Thank you for the email with a PDF of your Response Reports associated with the Stage 1 Road Safety Audits that we undertook of the proposed pedestrian refuge island along the A4 at Hare Hatch, RSA-25-055-1 and the on-site street layout, ref: RSA-25-069-1.

Project No: ITB21007  
Project Title: Ladds Garden Centre, Bath Road  
Title: Stage 1 Road Safety Audit – GG119 Response Format  
Ref: TW/BB/ITB210007-004 TN  
Date: 2 July 2025

## **Proposed Pedestrian Refuge Island along the A4 Bath Road Hare Hatch**

| DRAWING No:<br>ITB210007-GA-004   |                      |                       |   | REV:<br>B |          |

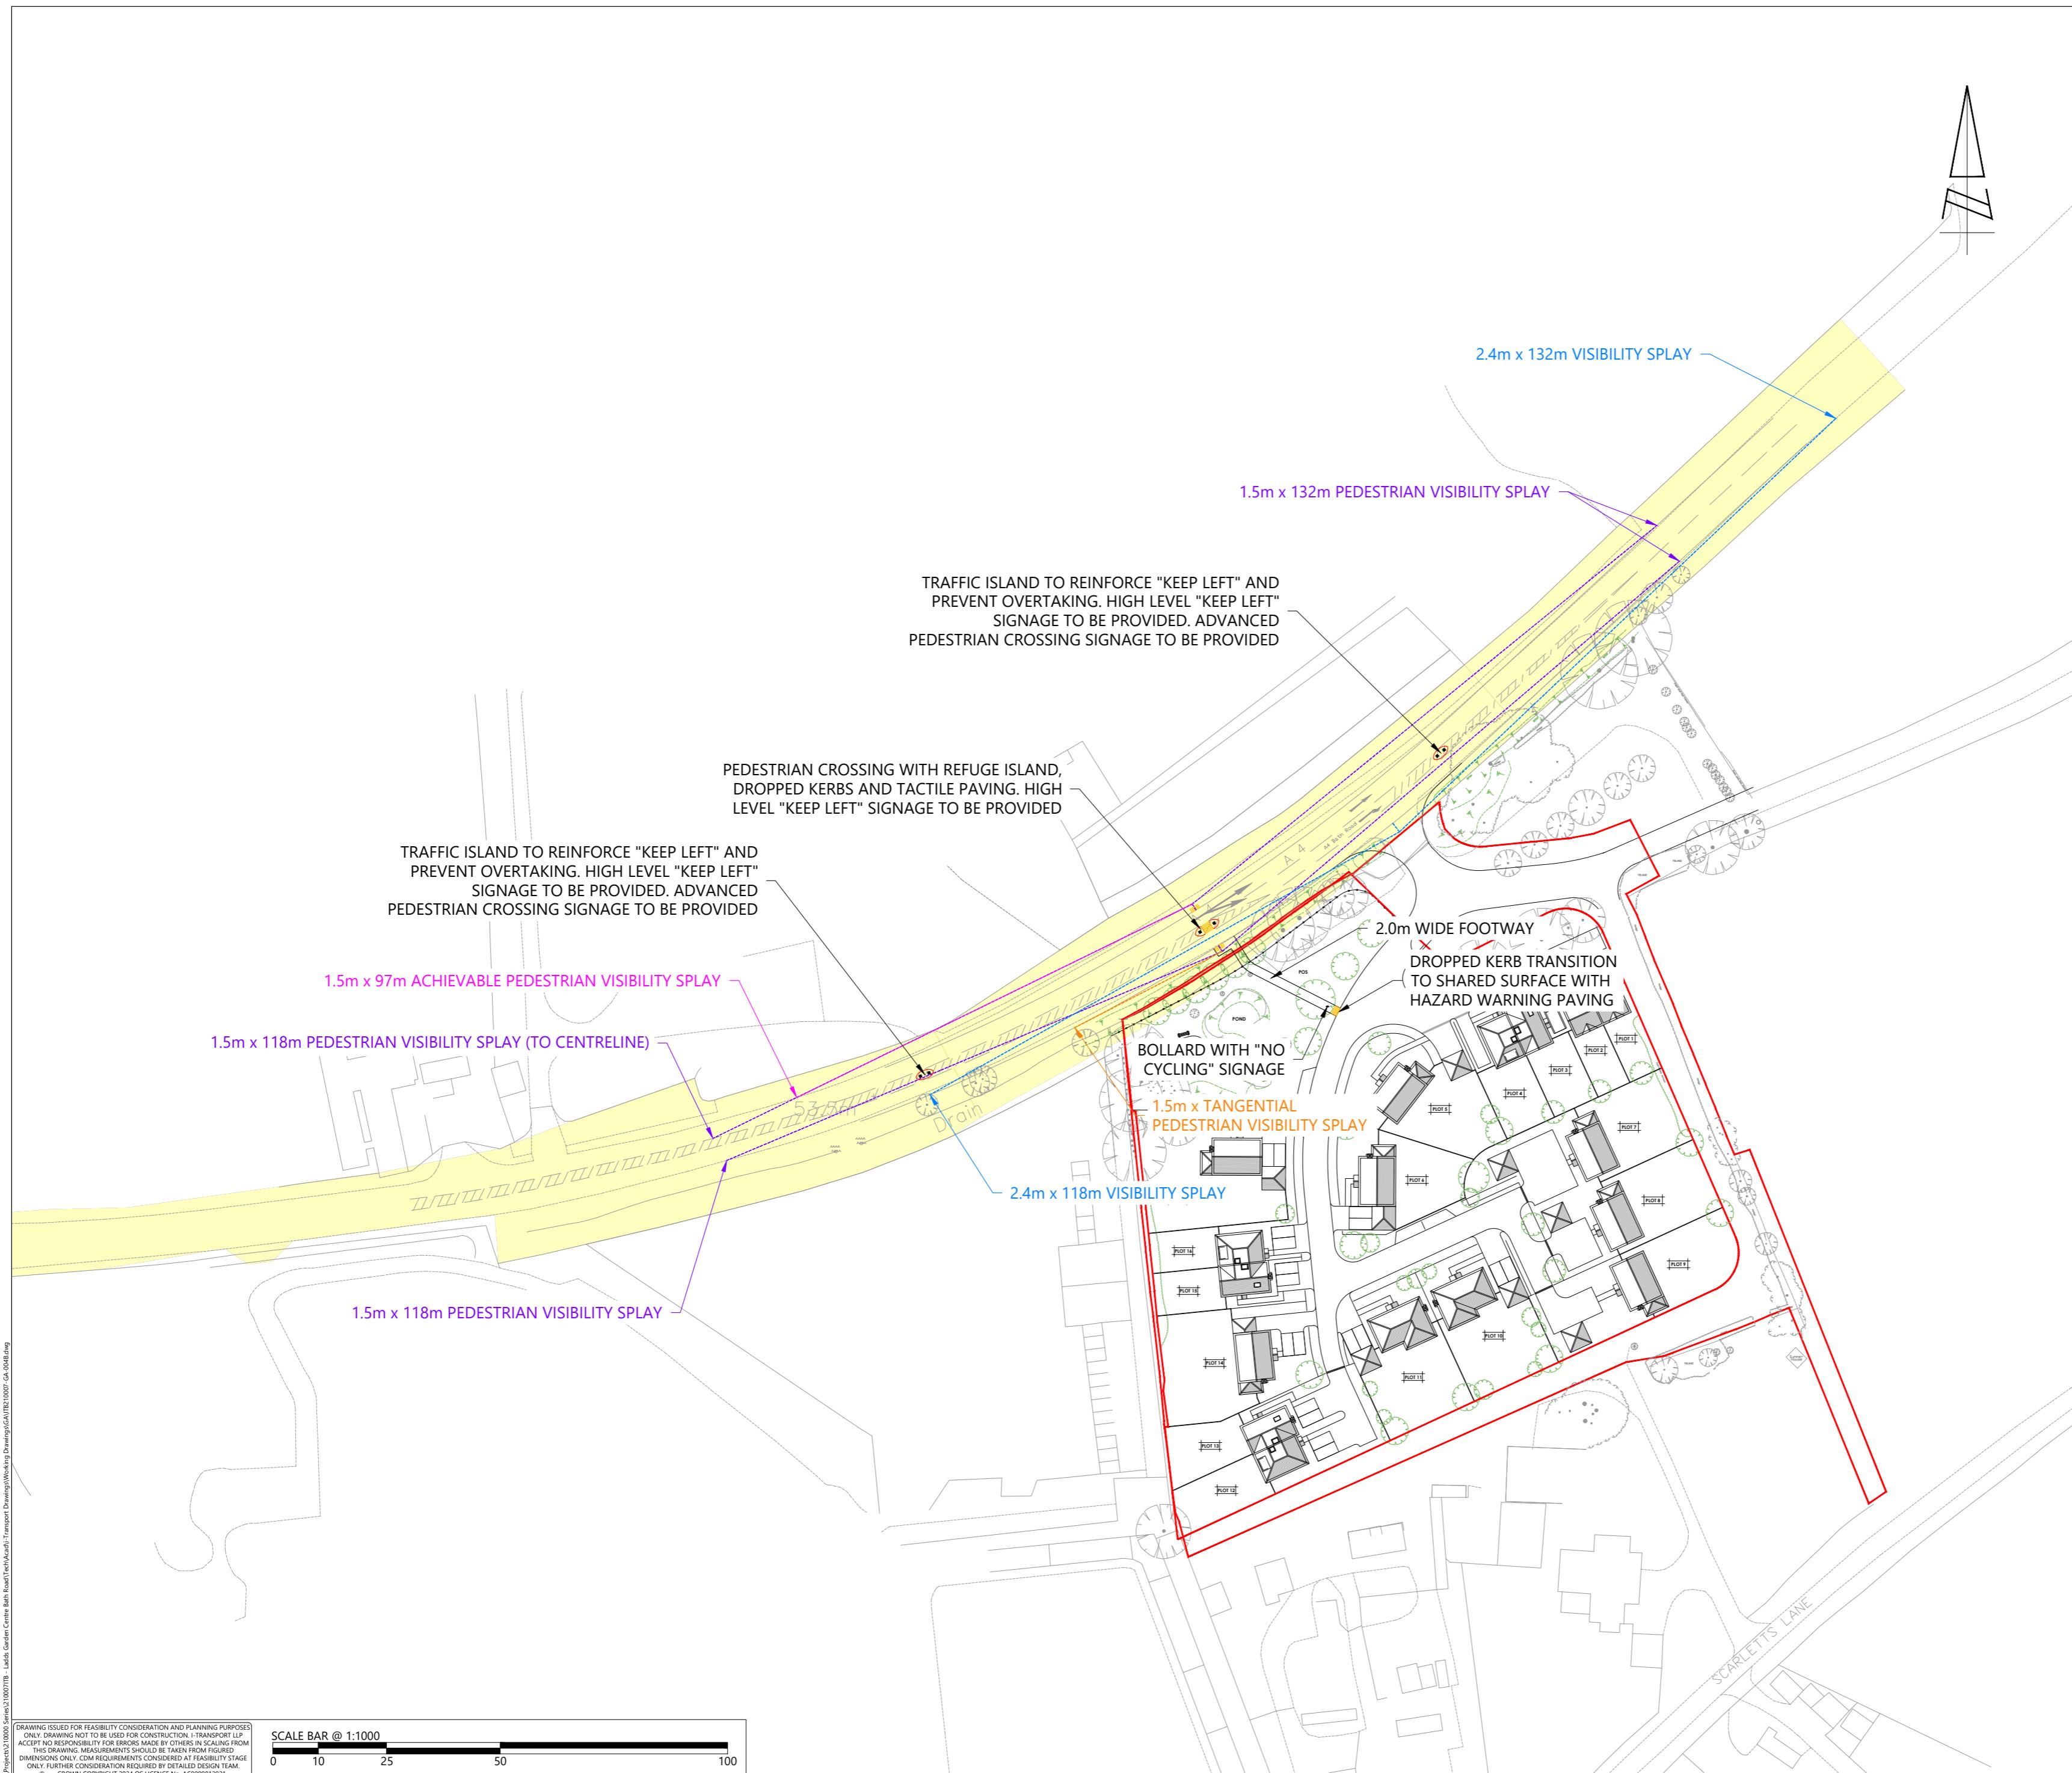
| RSA Problem   | RSA Recommendation   | Design Organisation Response   | Overseeing Organisation Response | Agreed RSA Action |
|---|--|--|----------------------------------|-------------------|
| <p><b>1:</b> The A4 Bath Road is subject to a 50mph speed limit in the vicinity of Ladds Garden Village but observes 85th percentile speeds of 43.9mph and 46.6mph in an eastbound and westbound directions respectively. A right turn lane is present to allow access to Ladds Garden Village without having an impact on the free flow of eastbound traffic travelling along the primary route. The proposals include the provision of corner radii at the existing priority access as well as an uncontrolled crossing point that is to be provided immediately to the west of the existing right turn lane which is proposed to allow access between the site and the existing footway network to the north of the carriageway. The scheme drawing illustrates that the uncontrolled crossing is to benefit from two rows of tactile paving and that the footpath connection between the proposed redevelopment and uncontrolled crossing point is to be straight in alignment with a marginal bend and in-line. Pedestrians should stop at the edge of the A4 Bath Road to become aware of approaching traffic and only attempt to cross when it is safe to do so. Nevertheless, the Audit Team have concerns that pedestrians particularly the visually impaired, could step over the proposed tactile paving and unknowingly enter the carriageway or approach at pace and attempt to cross the carriageway without looking. A pedestrian not stopping to become aware of approaching traffic could step into the path of a vehicle leading to a vehicle to pedestrian type collision.</p> | <p>The uncontrolled crossing point is offset from the approach and that the depth of tactile warning paving is increased if necessary.</p> | <p>Accepted – the design has been amended to offset the crossing point from the approach. The revised arrangements are shown on drawing no. <b>ITB210007-GA-004B</b></p> | <p>-</p>                         |                   |

| RSA Problem   | RSA Recommendation   | Design Organisation Response   | Overseeing Organisation Response | Agreed RSA Action |
|---|--|--|----------------------------------|-------------------|
| <p><b>2:</b> The A4 Bath Road is subject to a 50mph speed limit and follows a bend as it passes the western frontage of Ladds Garden Village. A right turn lane is formed within the carriageway to allow access to the Garden Village, which is 2.6 metres wide and formed with a taper to the east. The proposals include the provision of a pedestrian refuge island within the area of central hatching immediately to the west of the right turn lane. The scheme drawing illustrates that a 132 metre visibility slay is achievable to the east of the uncontrolled crossing point and therefore it is clear that westbound motorists will have visibility to the physical island in accordance with 85th percentile speeds. The Audit Team have concerns, however, that due to the bend in the road, the proposed keep left bollards won't be facing approaching westbound traffic and therefore the entire reflective face will not be clearly visible. As such, westbound motorists may not become aware of the physical island at a safe distance, particularly during the hours of darkness which could lead to a vehicle colliding with the physical island and a vehicle to pedestrian or loss of control type collisions.</p> | <p>It is recommended a splitter island is provided within the taper to the east of the right turn lane which will be directly in front of and therefore clearly visible to westbound motorists</p> | <p>Accepted – the design has been amended to provide a splitter island within the taper to the east of the right-turn lane, with associated "keep left" signage. The details of the signage to be provided will be confirmed at the detailed design stage. The revised arrangements are shown on drawing no. <b>ITB210007-GA-004B</b>.</p> | <p>-</p>                         | <p>-</p>          |

| RSA Problem  | RSA Recommendation  | Design Organisation Response  | Overseeing Organisation Response | Agreed RSA Action |
|--|---|---|----------------------------------|-------------------|
| <p><b>3:</b> The A4 Bath Road is subject to a 40mph speed limit within the village of Hare Hatch where a number right turn lanes are accommodated to allow access to amenities and properties off both sides of the carriageway. Those right turn lanes are separated by areas of central hatching to forming consistent eastbound and westbound lane widths. The carriageway follows a bend towards the eastern end of the village where the speed limit of the road changes from 40mph to 50mph, circa 160 metres to the west of the priority access and just circa 115 metres before the right turn lane associated with Ladds Garden Village. The proposals include the provision of an uncontrolled crossing point immediately to the west of the right turn lane associated with the Ladds Garden Village. Measurements have been taken from the scheme drawing and it has been determined that an eastbound motorist should be able to see the proposed refuge island from a point 139 metres in advance of the feature provided vegetation is cleared and maintained as indicated. This distance exceeds the stopping sight distance of a vehicle travelling at the 85th percentile speed recorded as well as that associated with the 40mph speed limit at that location. The Audit Team have concerns, however, that eastbound motorists may attempt to utilise the existing central hatched area to overtake slow moving vehicles and that the physical island will not be clearly visible due to its proposed location, around a left hand bend. Motorists not becoming aware of the proposed physical island at a safe distance could collide with the physical island leading to a vehicle to pedestrian or loss of control type collisions.</p> | <p>It is recommended that a series of physical islands are provided within the central hatching along the A4 Bath Road within Hare Hatch and extending to the proposed refuge island.</p> | <p>Accepted – the design has been amended to introduce a physical island on approach to the proposed pedestrian refuge island crossing from the west, with associated "keep left" signage and warning signage for the upcoming crossing. Approaching traffic from the west will have clear visibility to the new island, as demonstrated on drawing no. <b>ITB210007-GA-005</b>, ensuring they are aware of the upcoming crossing and that there will be no overtaking within vicinity of the crossing. The details of the signage to be provided will be confirmed at the detailed design stage. The revised arrangements are shown on drawing no. <b>ITB210007-GA-004B</b>.</p> |                                  |                   |

| RSA Problem   | RSA Recommendation   | Design Organisation Response   | Overseeing Organisation Response | Agreed RSA Action |
|---|--|--|----------------------------------|-------------------|
| <p><b>4:</b> The A4 Bath Road observes a high percentage of HGV's as well as other high sided vehicles and accommodates a number of traffic islands that benefit from keep left bollards as well as illuminated high level signs. The proposals include the provision of an uncontrolled crossing point that benefits from a refuge island. The scheme drawings illustrate that keep left bollards are to be installed on the physical islands, however, no high level signage is proposed. The Audit Team have concerns that motorists following high sided vehicles will not become aware of the proposed physical island at a safe distance and may attempt to overtake which could lead to a vehicle colliding with the island and a loss of control type collisions.</p> | <p>It is recommended that illuminated high-level keep-left signage is provided</p> | <p>Accepted – the design has been amended to provide high-level "keep left" signage at the proposed refuge island crossing, as well as at the newly proposed splitter islands which are visible on approach to the proposed crossing from the east and west. The details of the signage to be provided will be confirmed at the detailed design stage. The revised arrangements are shown on drawing no. <b>ITB210007-GA-004B</b>.</p> |                                  |                   |

5. The A4 Bath Road that is subject to street lighting in proximity to the village of Hare Hatch where a 40mph speed limit is present which increases to 50mph for eastbound traffic, at a point circa 160 metres to the west of the priority access and 115 metres before the right turn lane associated with Ladds Garden Village. The characteristics of the A4 Bath Road appear to change at the existing change in speed limit becoming more rural in nature with foliage both sides of the carriageway. The proposals include the provision of an uncontrolled crossing point immediately to the west of the existing right turn lane associated with the Ladds Garden Village, at a location immediately adjacent to an existing street lighting column. The scheme drawing illustrates that visibility slays in accordance with 85th percentile speeds are achievable from each crossing point, however, the 118 metre splay to the west of the northern uncontrolled crossing point extends to the road centreline rather than the channel line. It is noted that a splay of 97 metres is achievable to the channel line. The Audit Brief identifies that all visibility slays are to be cleared and maintained clear of obstructions and that the 118 metre splay to the road centre line represents a Departure from Standard (DfS), as the splay should extend to the nearside channel line. The proposed uncontrolled crossing benefits from a refuge and therefore users cross each 3.7 metre lane individually. As stated within Chapter 6 of Traffic Signs Manual, a lower walking speed of 1.0m/s is utilised to calculate timings for crossings which when applied to the lane width, would mean that a pedestrian is expected to be within the carriageway for 3.7 seconds. This is increased to 4.63 seconds when based on UCL research which identified that the average walking pace of an elderly pedestrian aged over 65 is 0.8m/s. It can be determined that an eastbound vehicle approaching the proposed uncontrolled crossing at the 85th percentile speed observed of 43.3mph, will take 5 seconds to travel

| RSA Problem   | RSA Recommendation | Design Organisation Response | Overseeing Organisation Response | Agreed RSA Action |
|---|--------------------|------------------------------|----------------------------------|-------------------|
| <p>the 97 metres. It is therefore clear that, provided the visibility splays illustrated are maintained clear, a pedestrian should have an adequate level of visibility to cross the 3.7 metre eastbound lane based on 85th percentile approach speed. It is noted, however, that traffic could legally travel at speeds in excess of the 85th percentile speed recorded which would render the achievable level of visibility insufficient. An eastbound motorist approaching a pedestrian who is crossing the eastbound lane will have clear visibility of the pedestrian within the carriageway ahead, even during the hours of darkness due to the presence of street lighting column, and should therefore adjust their speed accordingly. The Audit Team have concerns, however, that the route characteristics of the A4 Bath Road are to remain unchanged and rural in nature. Eastbound motorists are unlikely to expect a pedestrian to cross the carriageway at this location which could lead to heavy braking and loss of control type collisions.</p> |                    |                              |                                  |                   |

| RSA Problem   | RSA Recommendation  | Design Organisation Response  | Overseeing Organisation Response | Agreed RSA Action |
|---|---|---|----------------------------------|-------------------|
| <p><b>6.</b> The A4 Bath Road observes a traffic flow of circa 17,000 vehicles per day with circa 1500 vehicles observed in each direction during the peak hours, ref: ATC data provided in the Audit Brief. The proposals include the provision of an uncontrolled crossing point along the A4 Bath Road that is to benefit from a refuge island that is to provide a 2 metre by 2 metre refuge. The proposed refuge will allow pedestrians to each lane of traffic individually and therefore sufficient gaps should be available. The proposed uncontrolled crossing is primarily for pedestrians linking the existing footway to the north with a proposed footpath to the south. The Audit Team have concerns, however, that cyclists particularly child cyclists travelling between the site and destinations to the east or from destinations to the west and the site, may attempt to utilise the uncontrolled crossing. It is noted that the 2 metre by 2 metre refuge may not be adequate to accommodate a bicycle which could encroach into the through lanes and could be struck by a passing traffic leading to a vehicle to cyclist type collision.</p> | <p>It is recommended the depth of the refuge island is increased to accommodate a cyclist</p> | <p>Acknowledged – the proposed refuge island crossing is designed for pedestrians and provides a connection to the existing footway on the northern side of the A4 Bath Road. The crossing is not for use by cyclists given that it does not provide a connection to a designated off-carriageway cycle route. To ensure the proposed crossing is not utilised by cyclists, the design has been amended to introduce a bollard on the footpath leading to the crossing within the site and associated 'no cycling' signage. The details of the signage to be used will be confirmed at the detailed design stage. The revised arrangements are shown on drawing no. <b>ITB210007-GA-004B</b>.</p> |                                  |                   |

| It is recommended that appropriate warning signs are provided | Accepted – the design has been amended to provide appropriate warning signage for the approaching pedestrian crossing at the newly provided splitter islands to the east and west respectively. This will ensure motorists are aware of the presence of the pedestrian crossing. The details of the signage to be provided will be confirmed at the detailed design stage. The revised arrangements are shown on drawing no. <b>ITB210007-GA-004B</b> . |  |  |
